AGENDA
DESIGN COMMISSION
Commissions Room, 2nd Floor
Arlington Heights Village Hall, 33 S. Arlington Heights Rd.
Arlington Heights, IL 60005
October 14, 2025
6:30 PM

Design Commission
10/14/2025

Item: 1500 E. Euclid Ave. - SF/Teardown - DC25-065

STAFF DESIGN COMMISSION REPORT

1 PROPOSED SOUTH ELEVATION (STREET)
Scale: 1/4" = 1'-0"
0 2' 4' 8'

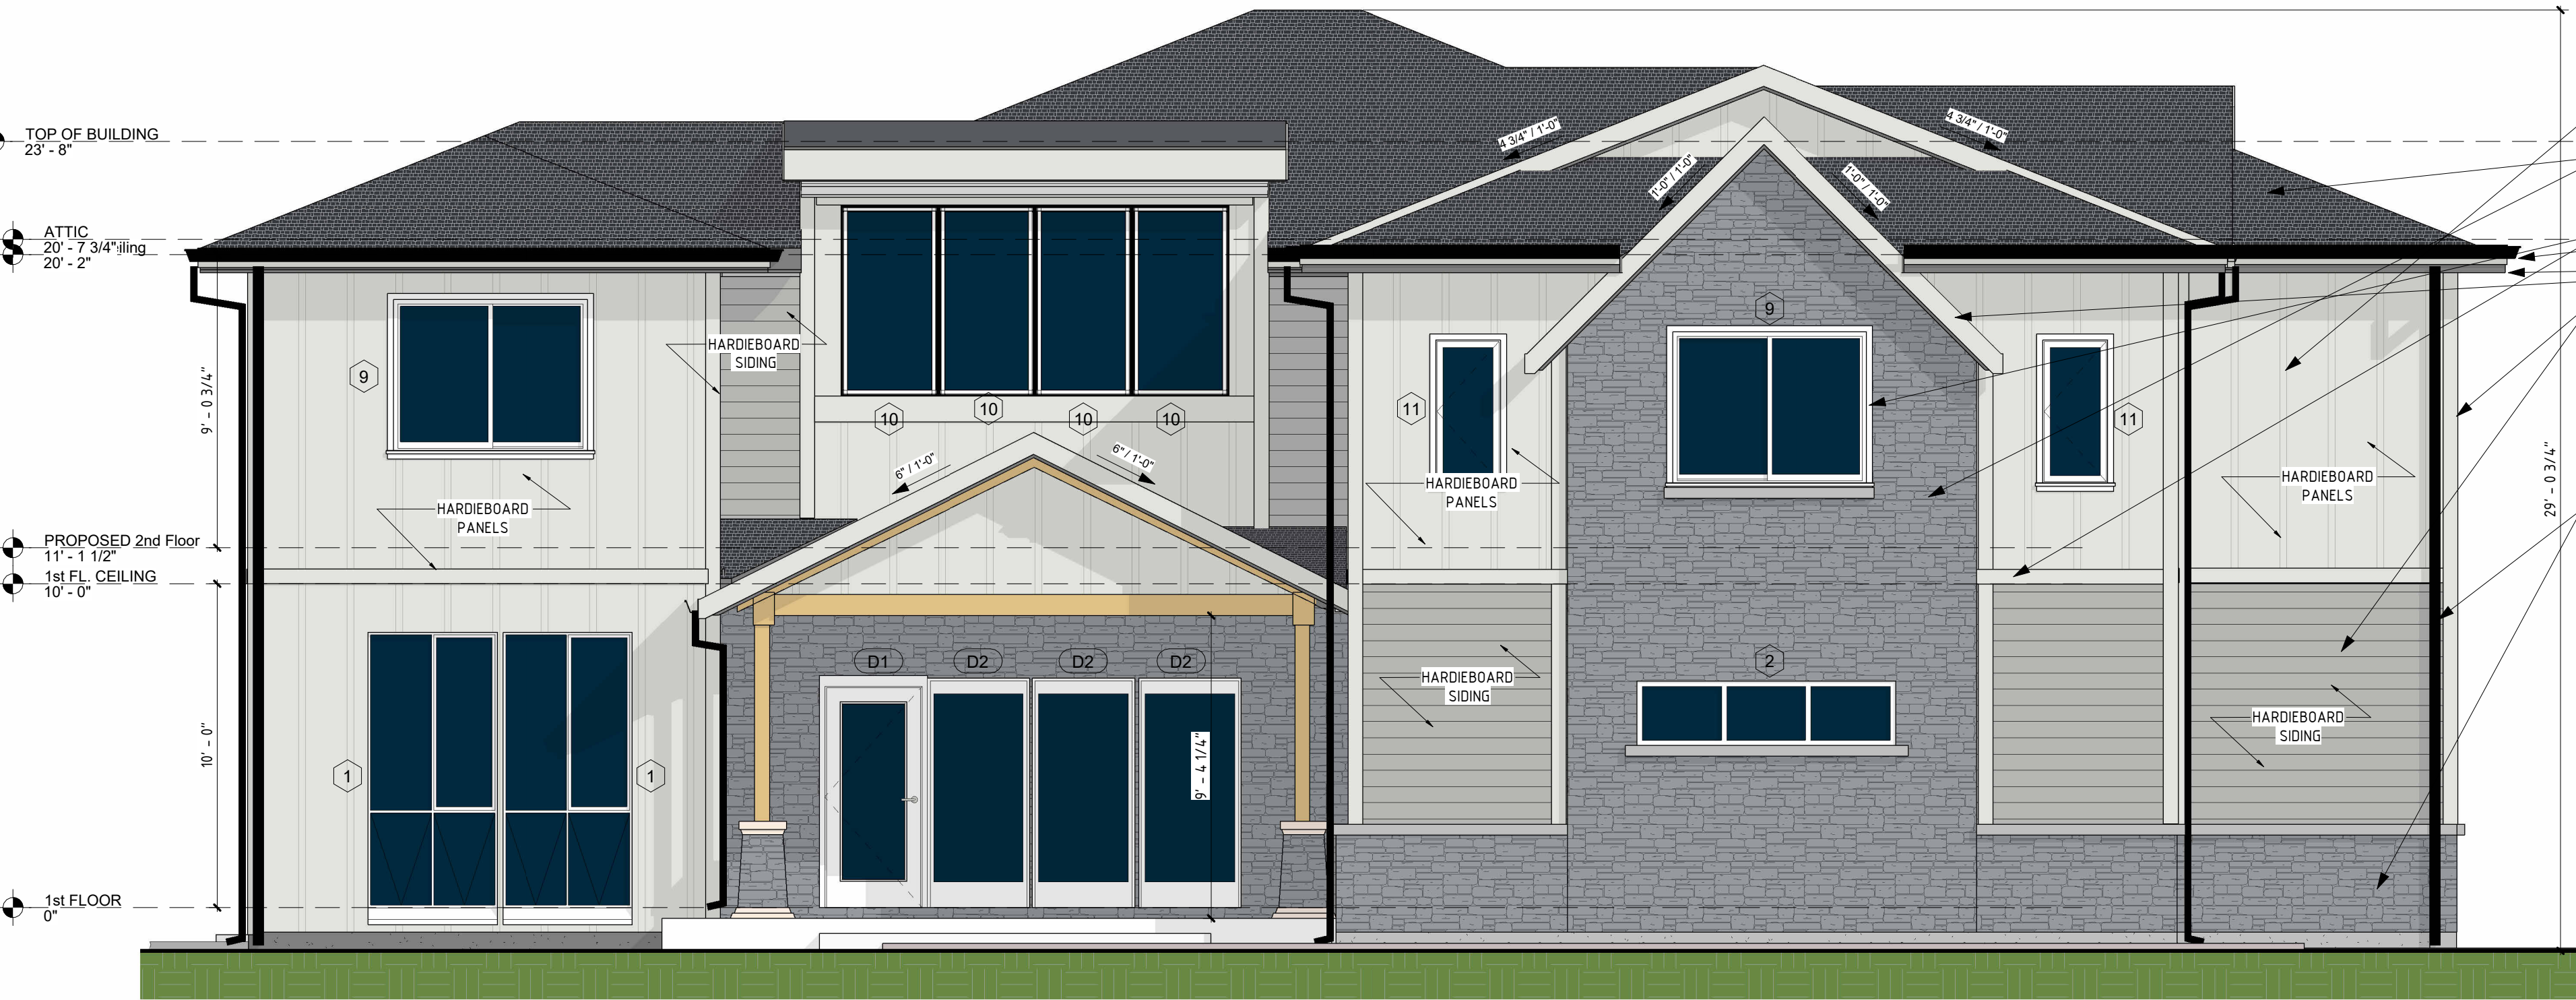
The proposed architectural design is comprised of primarily traditional forms, materials, and details. However, the overall composition has a busy and somewhat unresolved appearance primarily due to the numerous varying window sizes and window types which lack consistency or regularity. Additionally, the front entrance has an unusual appearance that looks more like a rear covered patio and patio door than a typical front entry design. The applied gable of stone on the front wall of the garage adds to the random appearance of the design and the steep roof pitch appears out of place with the rest of the house.

1. Per the Single-Family Design Guidelines, the Design Commission should evaluate the logic of the design, the overall composition and balance of the elevation, and the compatibility with the adjacent homes. Specific items to review include the varying window sizes and types, the unusual front entry design, and the random stone gable applied to the front wall of the garage.
